Office Action Summary	Application No. 10/542,259	Applicant(s) WISNIEWSKI, HORST	
	Examiner PHONG H. NGUYEN	Art Unit 3724

DETAILED ACTION

4. Claims 23 and 27-36 are rejected under 35 U.S.C. 103(a) as being unpatentable over Fernandez (5,865,358) in view of Gold (3,086,365).

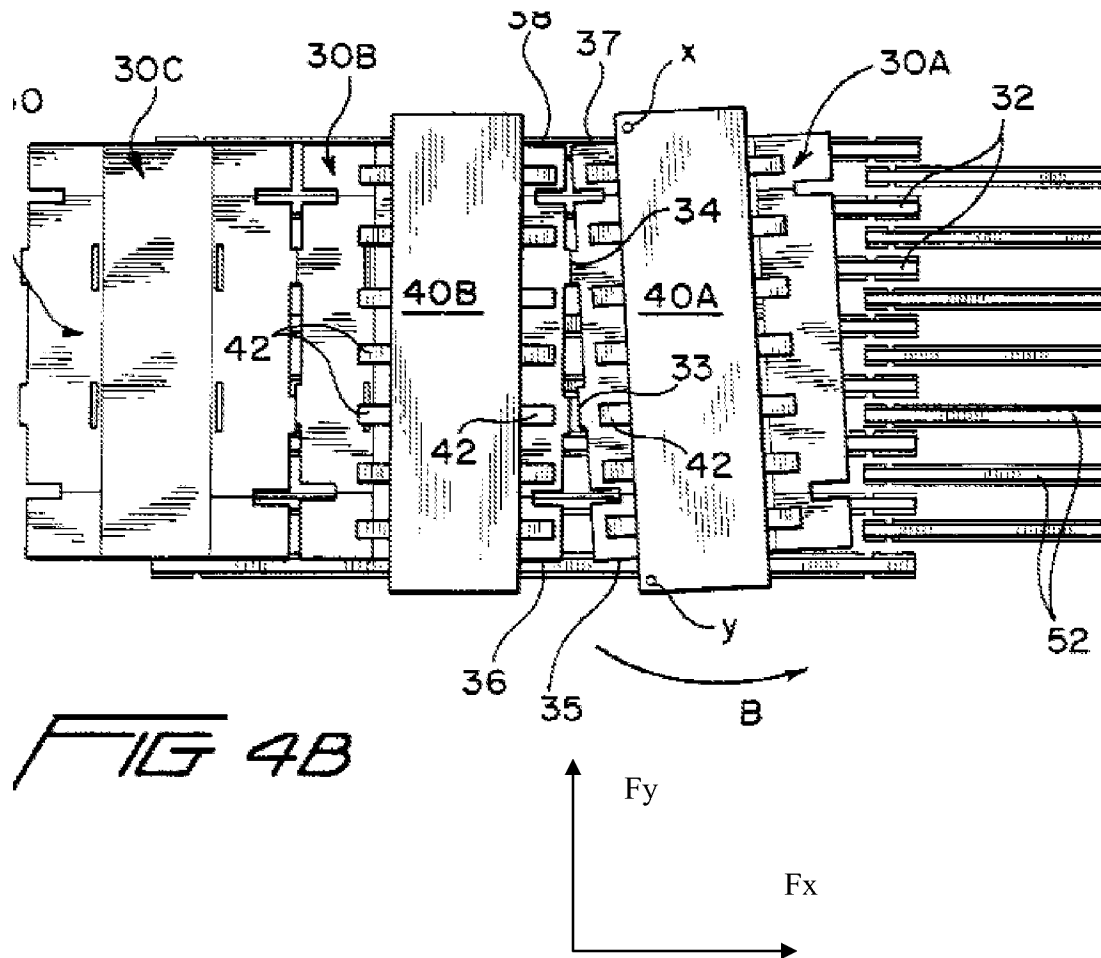
Regarding claim 35, as Gold's hydraulic system is incorporated into the Fernandez's device, the cylinder's 15 in Gold replaces the cylinder 86 in Fernandez.

Regarding claim 36, the cylinder 86 being connected to the base is best seen in Fig. 5 in Fernandez.

6. It is to be noted the pivoting movement of the pairs of jaws creates forces in x-direction (F_x) and y-direction (F_y). The force in x-direction causes tensile stress on the workpiece.
